**Report: TAB REPORT**  
**Function: Test, Adjust, & Balance**  
**Date: 03/25/2025**  
**Completed By: National TAB**

**03-24-25 CHIPOTLE #5326 GREENFIELD, WI**

Project: 03-24-25 CHIPOTLE #5326 GREENFIELD, WI

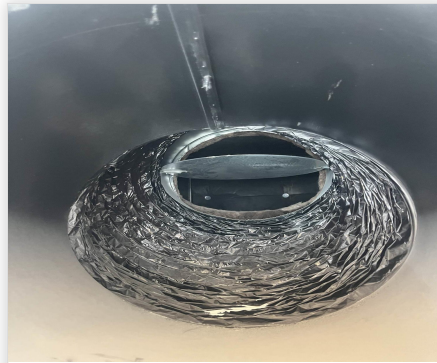
**Issue Name :** 02. RTU-2: Turbo Nozzle Diffusers Not Installed  
**Description :** Diffusers 2-3 thru 2-7 are not installed. Total supply air is balance to design. Unable to balance individual diffusers as installed dampers are not accessible and cannot be secured if adjusted. Turbo nozzles to be installed with face accessible dampers.

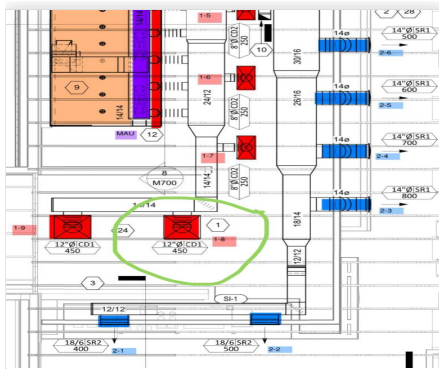
**Issue Name :** 03. RTU-1: Damper on diffuser 1-8  
**Description :** Wingnut on damper for diffuser 1-8 is stripped and will not tighten down. Damper position will likely move. Recommend hardware is replaced and damper secured 25% shut as pictured.  
**Created By :** National TAB                      **Assigned To :** National TAB - Michael McDonnell  
**Status :** Open  
**Priority :** Medium                                      **Asset Tag :**  
**Originated Date :** 03/25/2025 - Michael McDonnell - National TAB
